Coffs Harbour Bypass

Submissions Report

Volume 1. Executive summary, Chapters 1-3

Coffs Harbour Bypass
Native vegetation
Figure 3.4-1-03

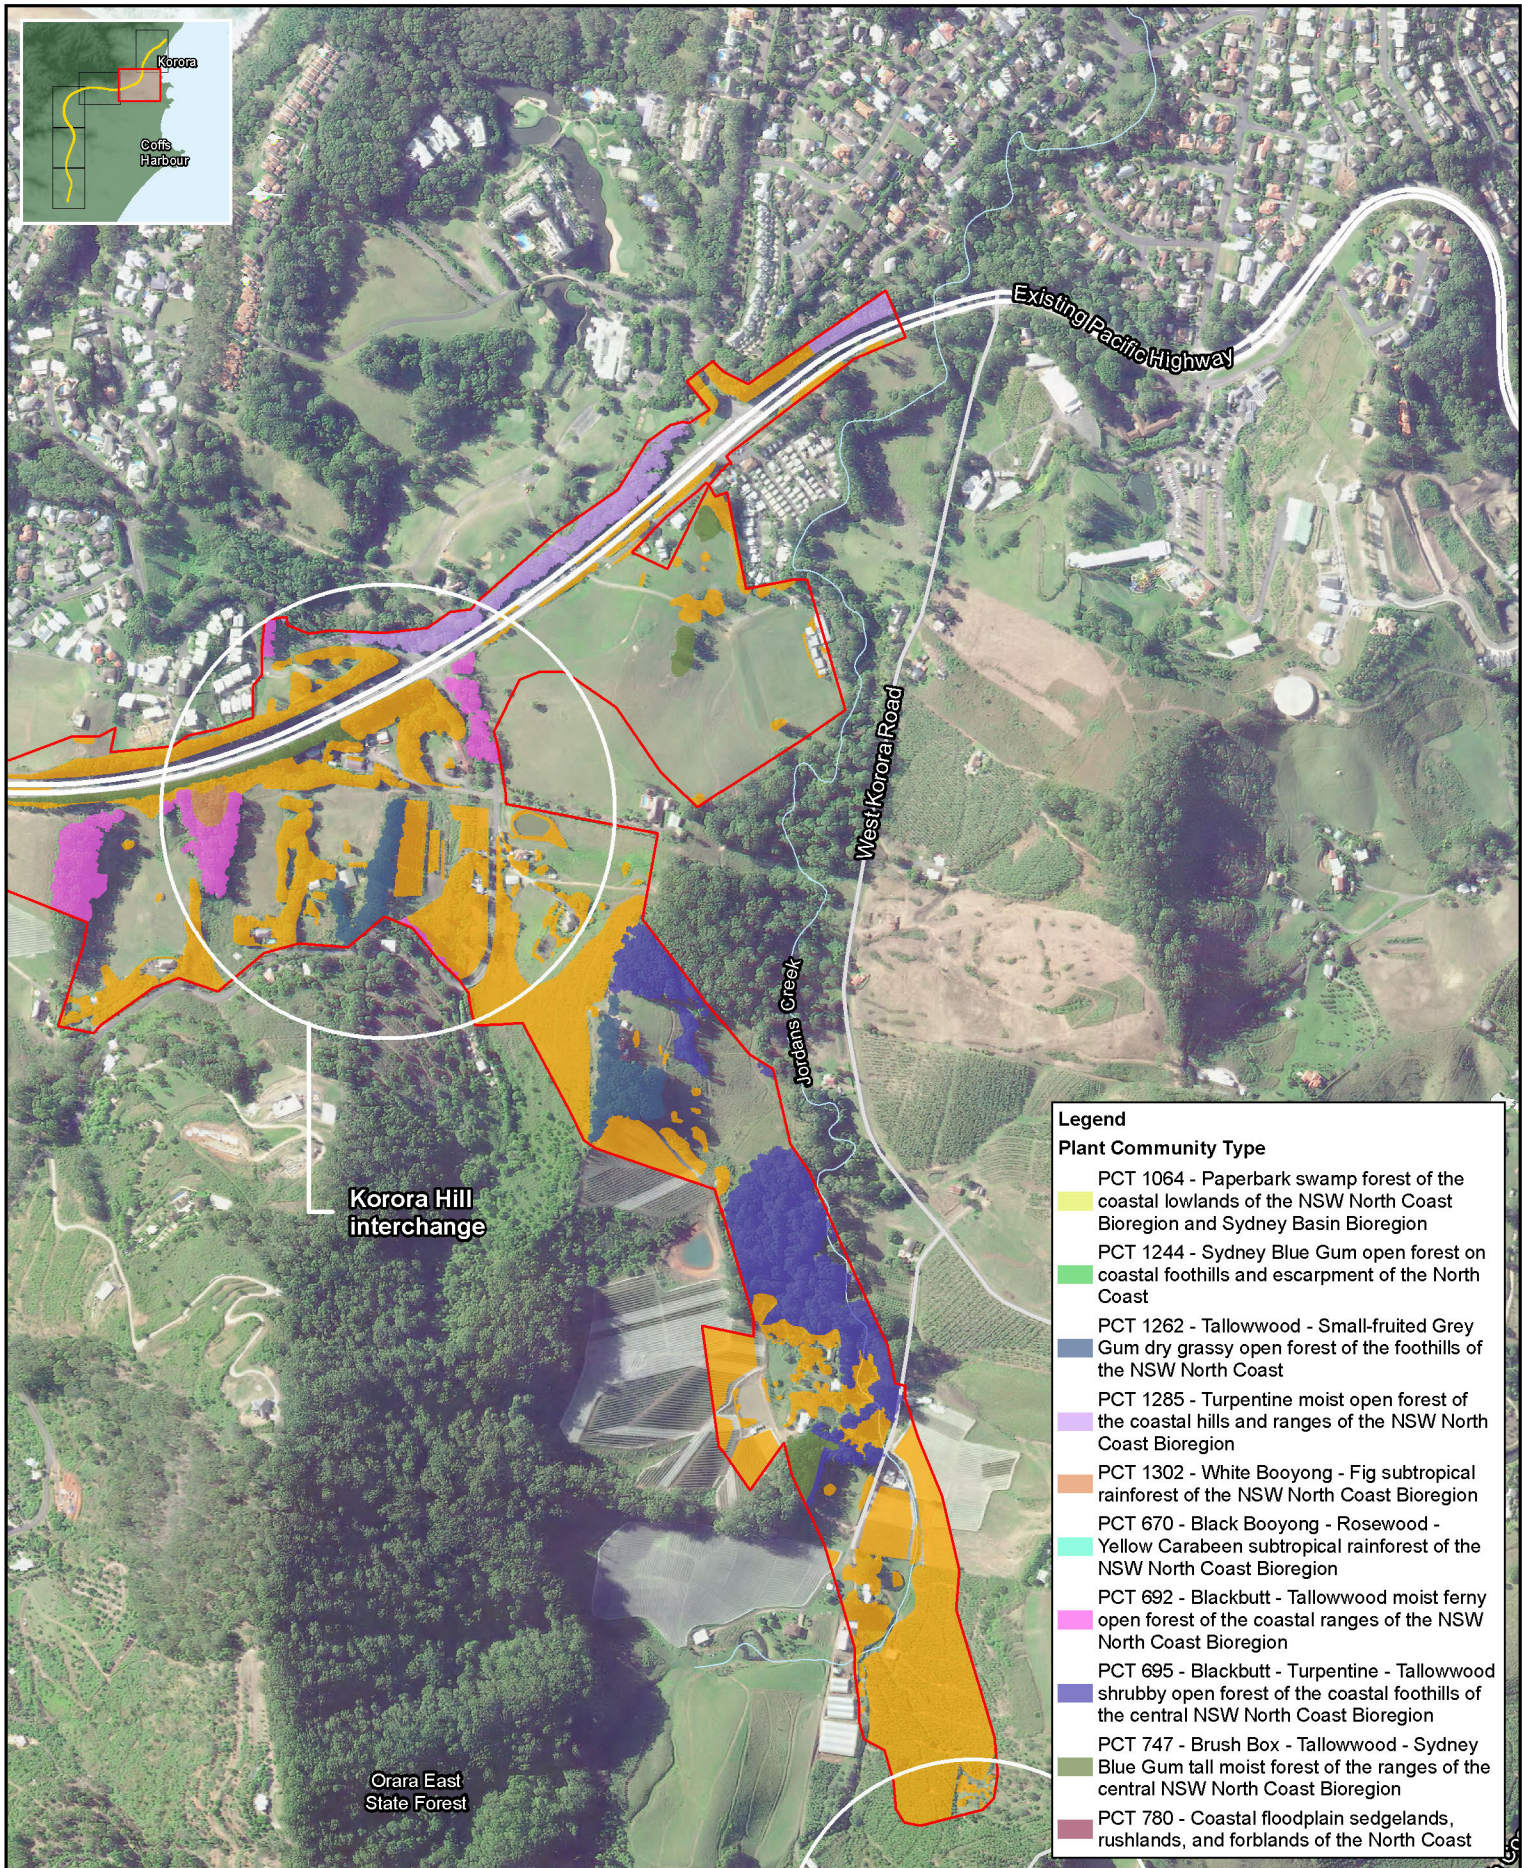
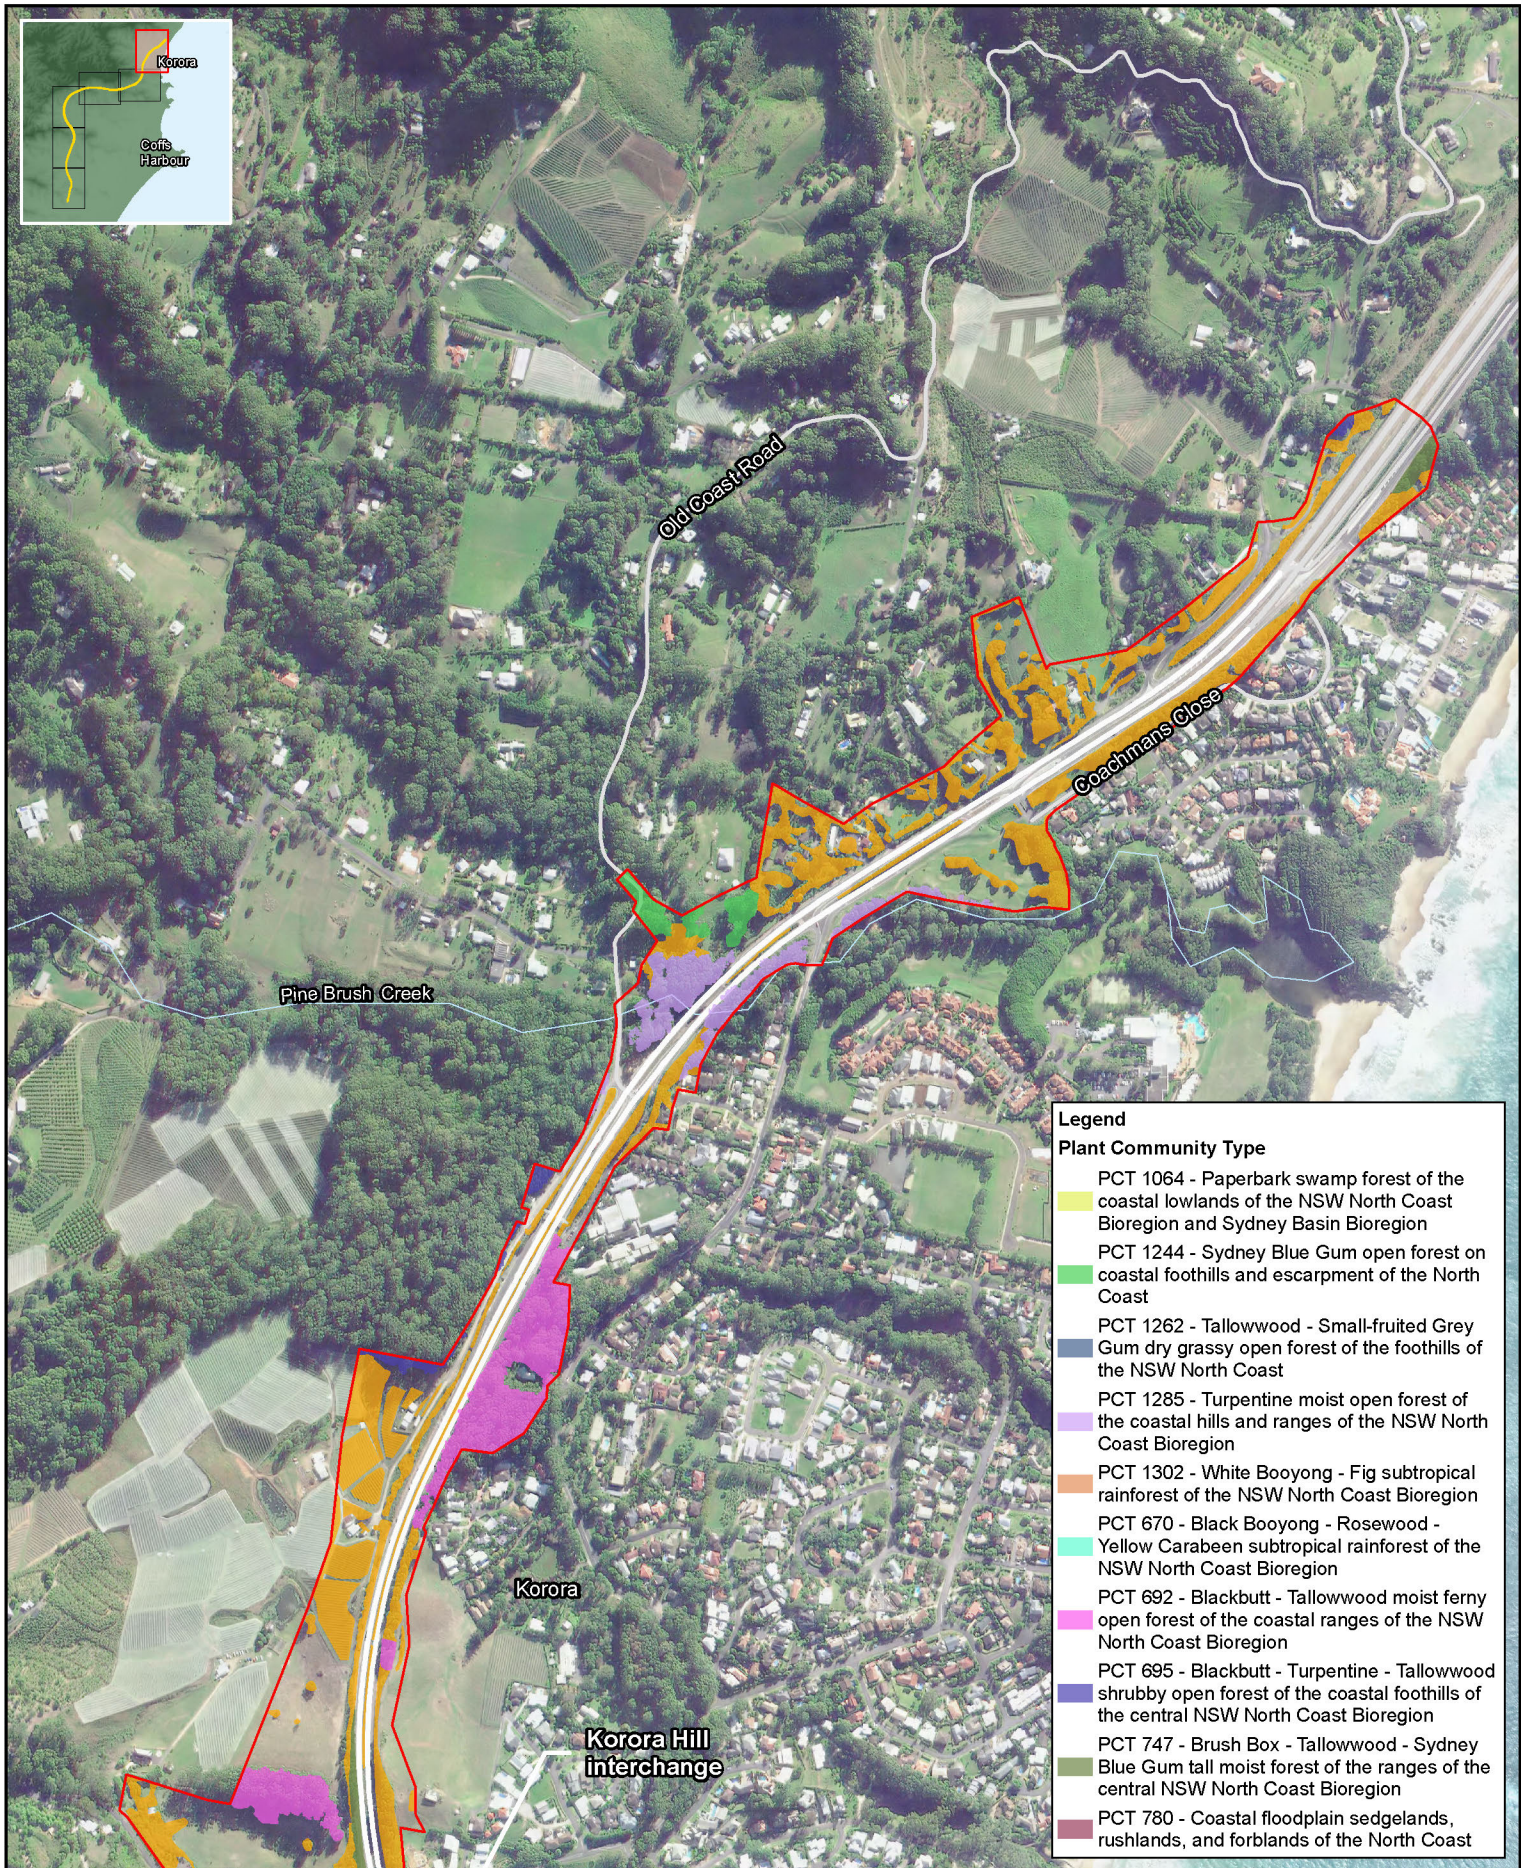
- Any areas of freshwater wetland within the development site must be mapped and assessed, and the results presented in the Biodiversity Assessment Report
- Any freshwater wetlands identified must be assessed to determine whether they align with the freshwater wetland on coastal floodplains endangered ecological community (EEC) determination.

- The two patches of wetland vegetation, north and south of North Boambee Road, have been added because of a change in the condition of the vegetation since the original PCT mapping was carried out in 2016. These areas are described in detail in Section 3.1.2 of Appendix C, Updated biodiversity assessment report of the Amendment Report and shown on Figures 4.1 to 4.7. Locations of updated PCT 780 are provided in **Figure 3.4-1-01** to **Figure 3.4-1-06**.

These areas are described in detail in Section 3.1.2 of Appendix C, Updated biodiversity assessment report of the Amendment Report and shown on **Figure 3.4-1-01** to **Figure 3.4-1-06**.
